Rev. As-built 1-12-89
Rev. 12-21-88

No.	Description	Title
	SITE GRADING & PRIVATE STORM SEWER LOT 2, BLK.1, HARVEST COMMUNIC. ADDN.

SURVEYING & ENGINEERING
 215 E. LINCOLN - WICHITA, KANSAS 67211

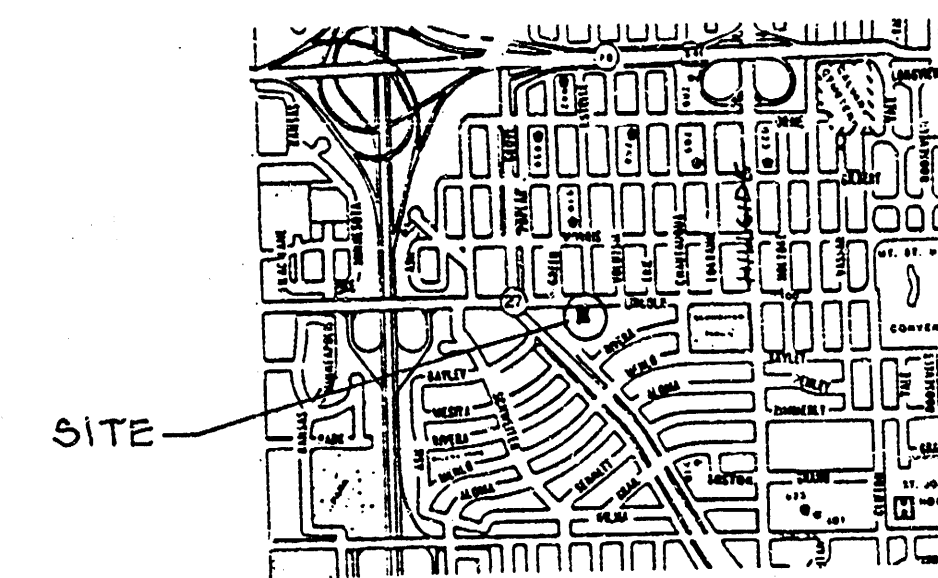
Sta. 0+~~00~~^{88.9} Construct
Std. 2' x 2' Drop Inlet
Top elev. 103.~~25~~⁹⁶
